ATLANTIC GOLD CORPORATION MARINETTE, NOVA SCOTIA BEAVER DAM MINE 088664-031

Round 2 Information Request Number:	CEAA-2-36
Regulatory Agency/Indigenous Community:	HC
Topic/Discipline:	Groundwater and Surface Water
EIS Guideline Reference:	Section 6.2 Predicted Changes to the Physical Environment
Revised EIS (February 28, 2019) Reference:	Section 6.6.6.2, p321
	Section 2.3.1.2, p113; 6.6.8, p330

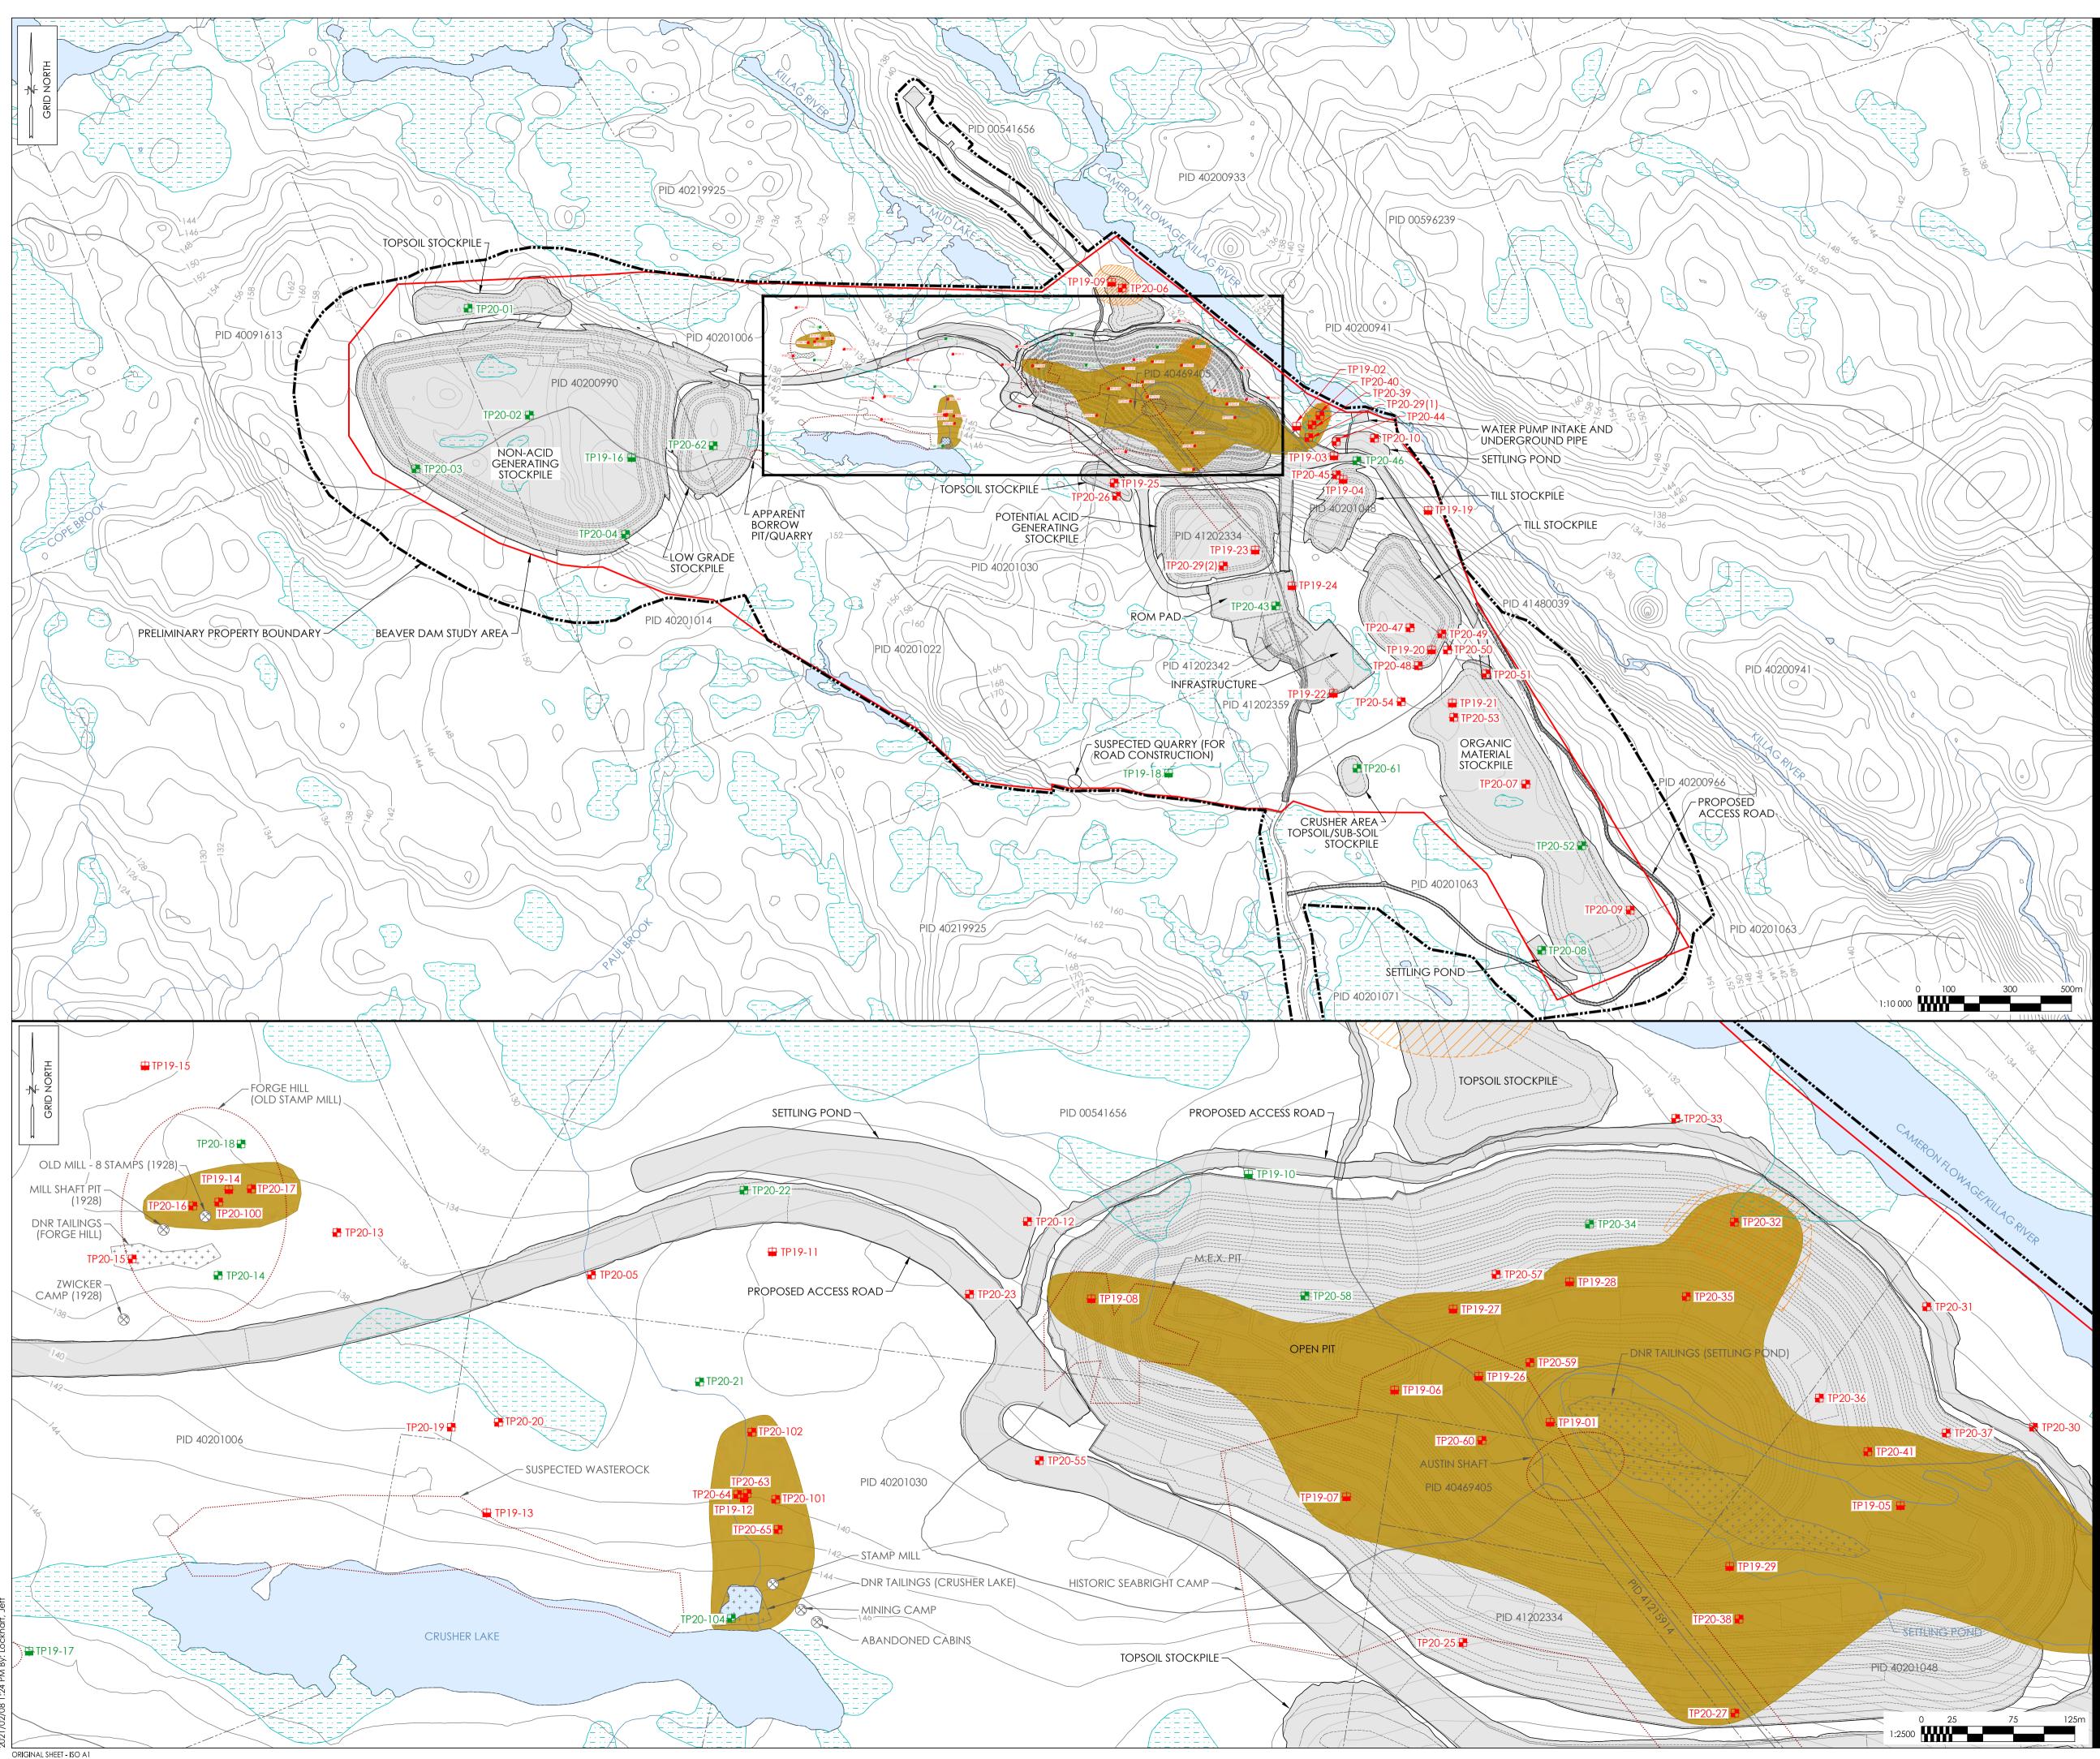
Round 2 Information Request Number:	CEAA-2-40
Regulatory Agency/Indigenous Community:	NRCan
Topic/Discipline:	Hydrogeochemistry
EIS Guideline Reference:	Part 2, Section 6 Effects Assessment; 6.1.3 Topography and Soil
Revised EIS (February 28, 2019) Reference:	Page 203-204, Section 6.5.3.2 Soils and Sediments;
	Appendix C.2, Evaluation of Exposure Potential Related to Dust Deposition from Haul Road Traffic onto Soils, Berries, and Vegetation, Table 2-1;
	Appendix E.2, Beaver Dam Project – ML/ARD Assessment Report, Table 4-9

From 2007 to 2010, the NSDNR and Geological Survey of Canada collected samples of soil and till throughout Nova Scotia that could provide additional insight into the geochemistry of soils and dust along the proposed haul route (Rencz et al. 2011; Friske et al. 2014a, 2014b). These surveys sampled individual soil horizons, including the "Public Health" layer (0-5 cm) and would augment data for the 11 soil samples collected along the haul road in 2018 (Appendix C.2). Geochemical data from these surveys would also be useful for establishing background concentrations for a wide range of elements from other parts of the Meguma Supergroup with similar bedrock and surficial geology to the Beaver Dam site. Based on the results of these surveys, include discussion on the main processes that might control the spatial distribution of elements such as arsenic, which exceeds CCME soil quality guidelines in 29 of 98 till samples near the project site (page 203, section 6.5.3.2) and in all of the overburden samples collected for ML/ARD testing (Appendix E.2, Table 4-9). These data would serve as a baseline for future environmental monitoring activities and help guide reclamation efforts.

Results of the laboratory analysis of soil samples are presented on Drawing No. A-5, PDF page 40, Appendix A, PDF page 35 and Table C-1, PDF page 140, Appendix C, PDF page 139 and discussed in Section 3.3.1, PDF page 23 of the Extended Phase II ESA (Appendix E.8 [Stantec, 2021]) of the Updated 2021 EIS (AMNS 2021). Appendix E.8, Drawing No. A-5, PDF page 40 is also attached as Figure CEAA 2-40-1.

Arsenic levels below the 95th percentile value (228 mg/kg) of the background non-impacted data set were considered to represent arsenic not related to historical mining activities. Delineation based on this value, as well as on field observations, is shown on Drawing No. A-5, PDF page 40, Appendix A of the Extended Phase II ESA Appendix E.8 [Stantec, 2021]) of the Updated 2021 EIS (AMNS 2021). Drawing No. A-5, PDF page 40 is also attached as Figure CEAA 2-40-1.

Historical mining-related arsenic contamination in soil identified during the Limited Phase II ESA and Extended Phase II ESA is horizontally delineated other than to the northeast of the proposed open pit near the Cameron Flowage, as shown by dashed lines on Drawing No. A-5, PDF page 40, Appendix A, PDF page 35 of the Extended Phase II ESA (Appendix E.8 [Stantec, 2021]) of the Updated 2021 EIS (AMNS 2021). Drawing No. A-5, PDF page 40 is also attached as Figure CEAA 2-40-1.

FIGURE CEAA-2-41-1a

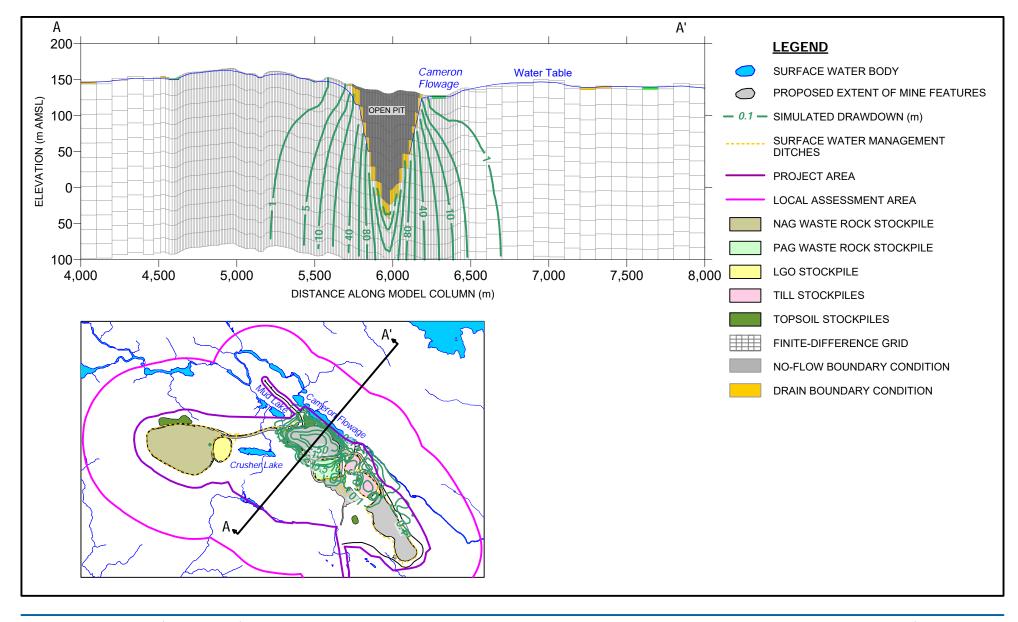
The simulation of the drawdowns caused by the dewatering activities was done using drains along the wall and at the bottom of the open pit. Figures 7.1a-b, 7.2a-b and 7.3a-b in Appendix F.5 show that resulting drawdowns close to the open pit will be in the order of 4 m. Given that the depth of the open pit will be up to 200 m, those drawdowns appear to be very low in comparison.

Provide a cross-section through the Beaver Dam open pit with drawdowns and hydraulic heads depicted as a figure to give a better perspective of the induced drawdowns.

Figures 7.4a, PDF page 98 through 7.6b, PDF page 103 in Appendix F.5 (Hydrogeologic Modelling Report) of the Updated 2021 EIS (AMNS 2021) present cross-sections through the Beaver Dam open pit showing simulated drawdown. These figures are attached to this Round 2 Information Request response (IR2; CEAA-2-41) as Figures CEAA -2-41-1a to CEAA 2-41-3b for ease of reference.

As shown on Figures CEAA 2-41-1a, CEAA 2-41-2a and CEAA 2-41-3a a seepage face is simulated along the pit walls at depth for end-of-mine (EOM) (i.e., approximately 75 to 95 m below ground surface to the bottom of the pit). The seepage face, and seepage along the pit walls, is simulated in all predictive scenarios presented in Section 7.4, PDF page 46 of Appendix F.5 and the impacts are assessed for nearby surface waterbodies, including Cameron Flowage, for both flow and contaminant transport assessments. Section 7.1, PDF page 41 in Appendix F.5 presents the methodology applied in the predictive scenarios (AMNS 2021). Section 7.4, PDF page 46 in Appendix F.5 presents the simulations results for each EOM and post-closure (PC) scenario including the simulation of groundwater inflow rates into the open pit (Section 7.4.1, PDF page 46 in Appendix F.5), simulation of drawdown at EOM and PC (Section 7.4.2, PDF page 46 in Appendix F.5), estimation of the pit infilling rate (Section 7.4.3, PDF page 46 in Appendix F.5), simulation of impacts to baseflow for EOM and PC (Section 7.4.4, PDF page 46 in Appendix F.5), and
